# UNITED STATES PATENT AND TRADEMARK OFFICE

## Office Action Summary

10/055,757

### **DETAILED ACTION**

Attachment #1

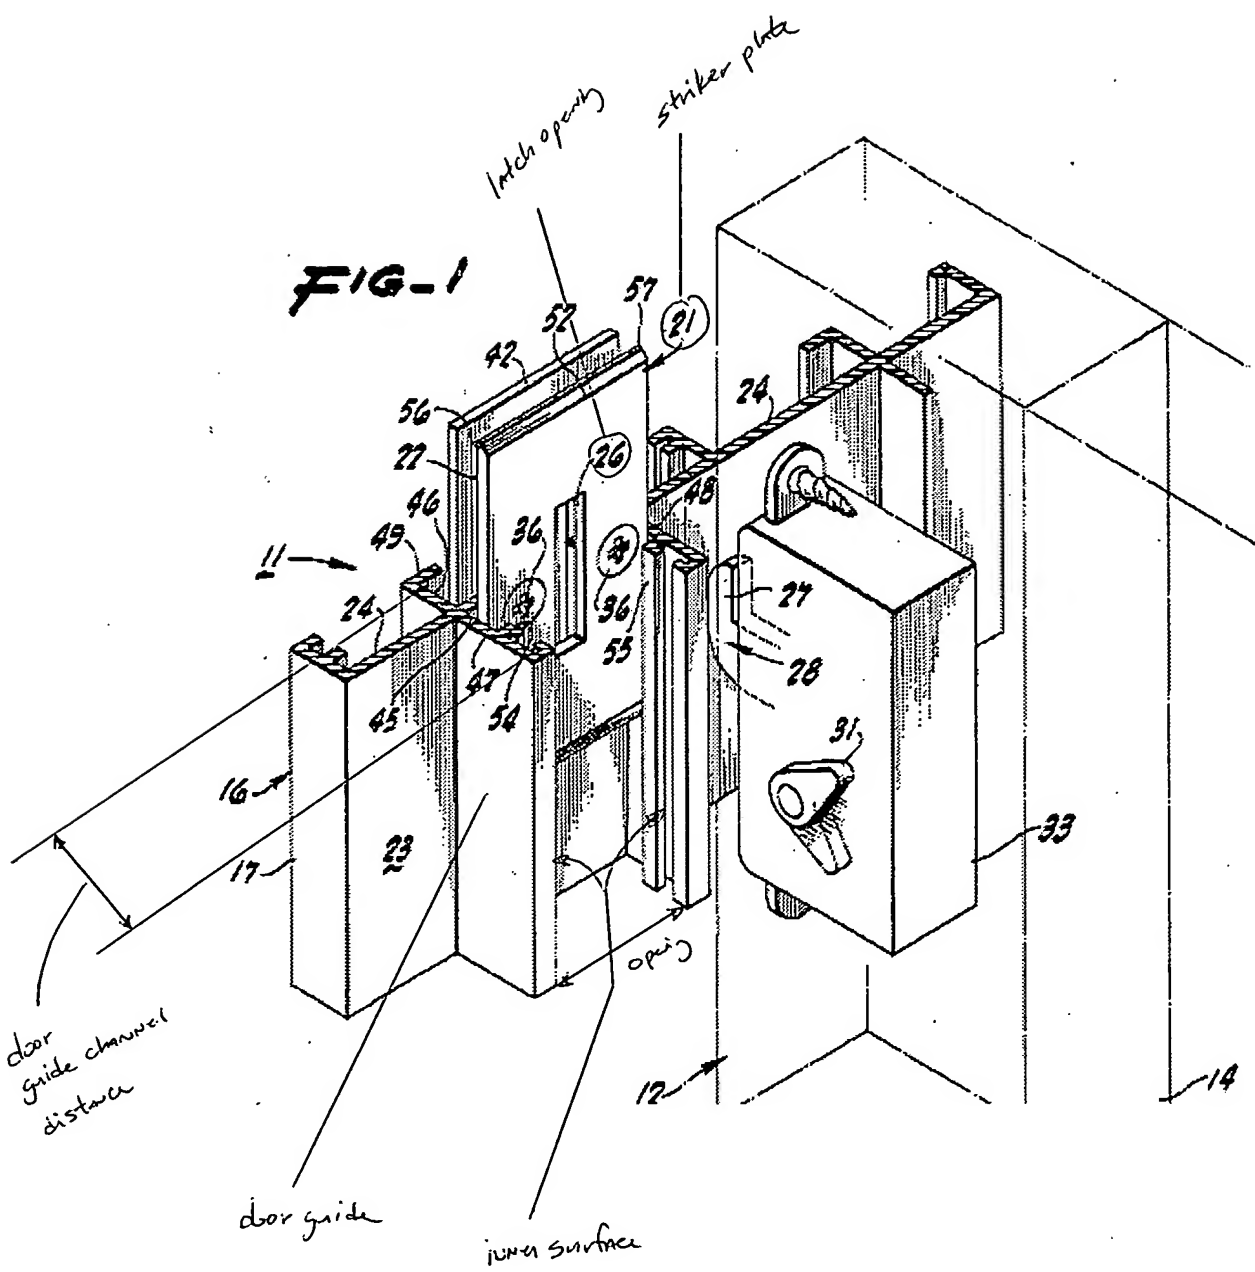
Regarding claims 1 and 20, Collier discloses an adjustable door guide latch slot assembly comprising a striker plate (21) having a latch opening (26), and a door guide (see attachment #1).

The door guide has a channel sized to retain a door slidably therein that includes an inner surface and an opening. The opening of the door guide is larger than the opening of the striker plate.

The striker plate may be adjustably affixed directly to the door guide inner surface so that the striker plate latch opening aligns with the latch of the door.
